Product Change Notification

From:	ept GmbH
PCN:	1852/2019
Date:	16.08.2019

One27 – Male connectors, straight

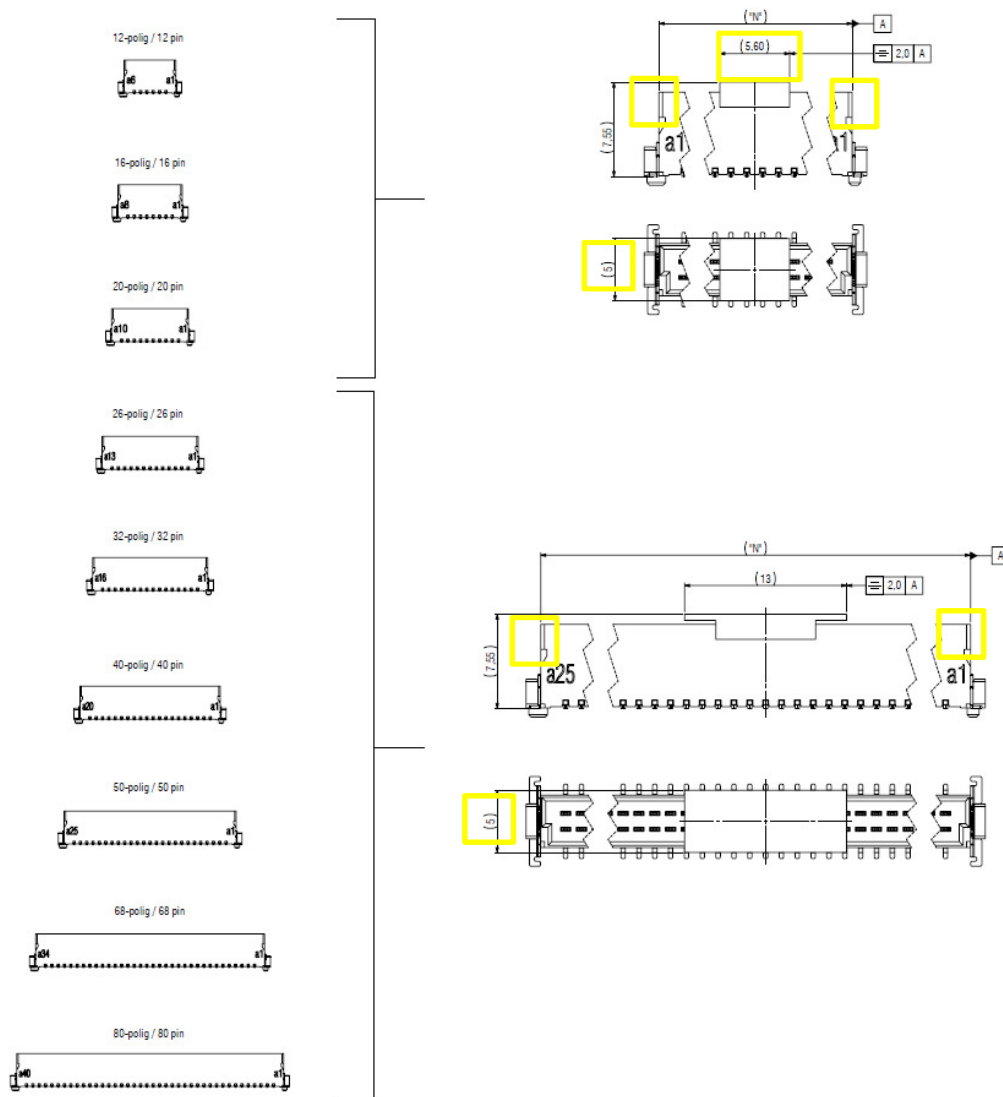
Description of change: Change of pick & place pad, cut out in insulation body

Old version: One cap for all pin counts, length = 6,25 mm

New version: two different caps for all pin counts, length = 5 mm

Pick and place pad: Optimization automated optical inspection (AOI) for contacts & anti twist safe guard

Cut out in insulation body: prevents collision with right angled female connector
